East Lancashire Paper Mill, Radcliffe

Response to Active Travel England

1.1.1 This Technical Note (TN) has been produced by Mode Transport Planning ('Mode'), on behalf of Morris Homes, in relation to a reserved matters application (App Ref : 70284) for 400no. residential dwellings at the former East Lancs Paper Mill (ELPM) site in Radcliffe.

1.1.2 This note (TN03) has been prepared in response to comments received from Active Travel England (ATE), dated 26th January 2024, which are attached in [Appendix A](#).

Figure 2.3 : Formal Pedestrian Routes and Informal Routes (image source : Morris Homes)

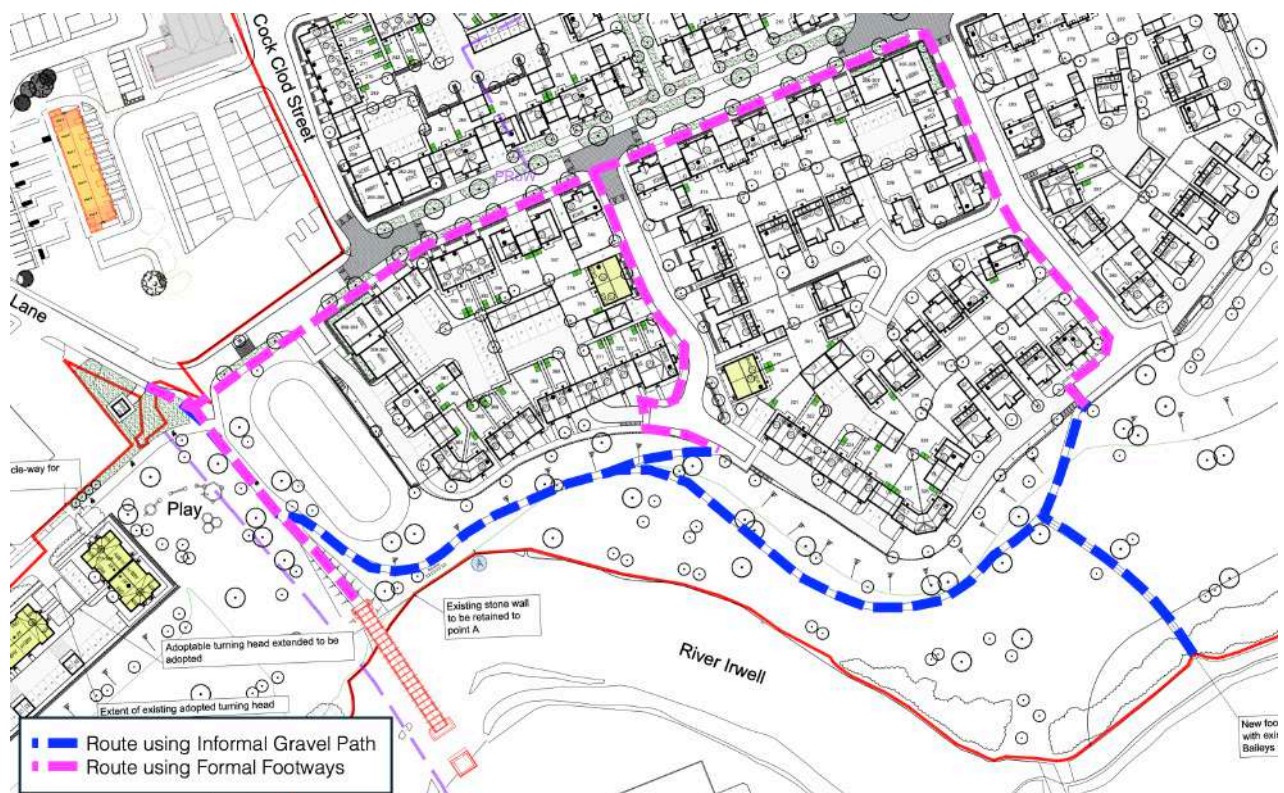
2.5.1 It is noted that ATE has raised concern regarding the provision of some gravel footpaths. These informal footpaths are located within the flood plain and the surfacing type has been proposed with consideration to the environmental requirements within this area of the site.

The masterplan incorporates and therefore encourages physical activity via a number of routes to the south of the housing that are defined on both the original outline masterplan as well as the submitted layout. While these are welcomed, they are fewer in number than the 2018 masterplan while their future utility are of significant concern where they are poorly surfaced in finishes such as loose-bound gravel.

Surface quality affects the comfort and effort required when using a pushchair, wheelchair or a mobility scooter. Loose surfaces such as gravel or mud can also present a skidding hazard, increase the risk of punctures and make clothing dirty in bad weather. Users are also affected by ruts and potholes that can throw them off balance. Smooth, sealed solid surfaces offer the best conditions for reliable everyday use.

ATE is aware of a number of examples of where a non-sealed surface has worn badly and became unsuitable. Self-binding gravel can often be loose and dusty, have poor skid resistance, and is not durable. Given the aims of this development to encourage active lifestyles, it would seem sensible to insist on a surface that can support future high levels of use without becoming unusable or requiring a high level of maintenance.

Inclusive mobility: making transport accessible for passengers and pedestrians states on page 124 in the chapter on Access to the Countryside states that 'All path surfaces should be compact, firm and stable' and that 'Loose sand, gravel, woodchips and cobbles should not be used'. The use of such material in this location does not 'address the needs of people with disabilities and reduced mobility in relation to all modes of transport' as required by NPPF paragraph 112 b.

2.5.2 It should also be reiterated that the gravel footpaths are informal and are therefore not required to be constructed to the standard suggested by ATE. The informal footpaths are not exclusive routes, and there are formal routes proposed within the site from Rectory Lane which are surfaced to an adoptable standard. Both the formal and informal routes as shown in [Figure 2.2](#).

2.5.3 In addition, the informal routes have no onward links to accessible areas and lead to naturally steep and vegetated areas.

- 2.5.4 Whilst these gravel surfaces may not provide the most appropriate surface for pushchairs, wheelchairs and mobility scooters, alternative formal footpaths are available for users. The informal routes are therefore more suited as leisure routes, which will be used less frequently, as intended.
- 2.5.5 Play areas located within the open space have been located to have direct connections to formal surfaced routes.
